PERFORMANCE SPECIFICATION SHEET

RELAY, SOLID-STATE, HERMETICALLY SEALED, CLASS II, OPTICALLY ISOLATED,
ZERO VOLTAGE TURN-ON, 1 AMPERE (2 AMPERES WITH HEAT SINK),
400 HZ, POWER SWITCHING, SPST (N.O.)

This amendment forms a part of MIL-PRF-28750/9C dated 1 February 1999, and is approved for use by all Departments and Agencies of the Department of Defense.

MIL-PRF-28750/9C
AMENDMENT 3

FIGURE 5. Broadband conducted emissions.”

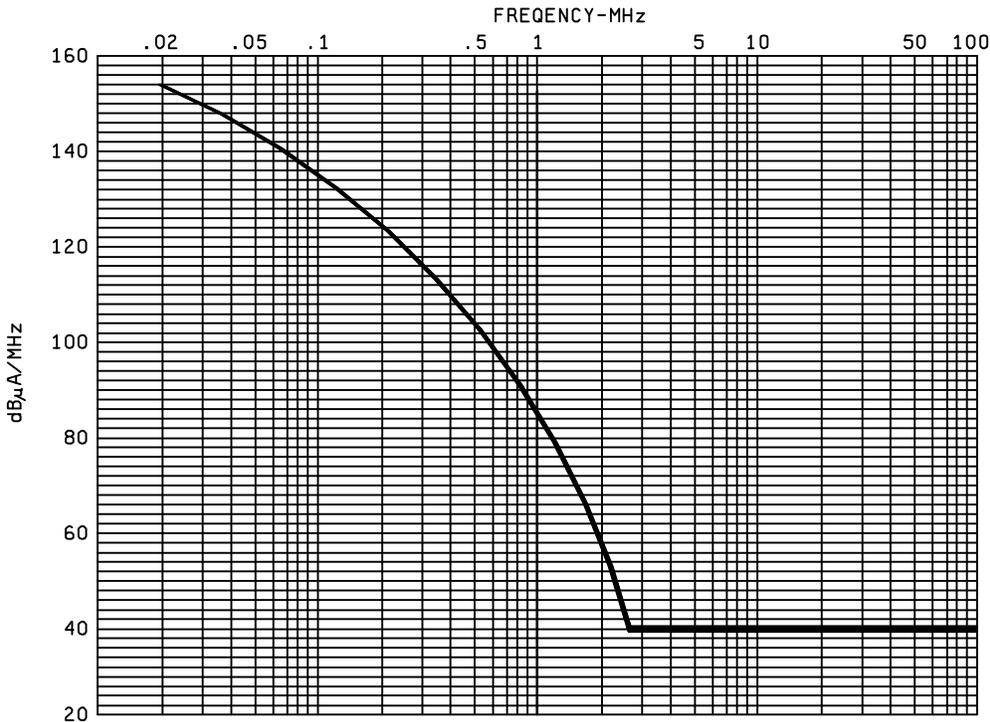
* Add a figure 5:

- * Add a paragraph: "Electromagnetic interference: Maximum broadband conducted emission on power lines with 115 V ac, 400 Hz, 1.0 ampere resistive load during steady state and switching conditions (see figure 5)."
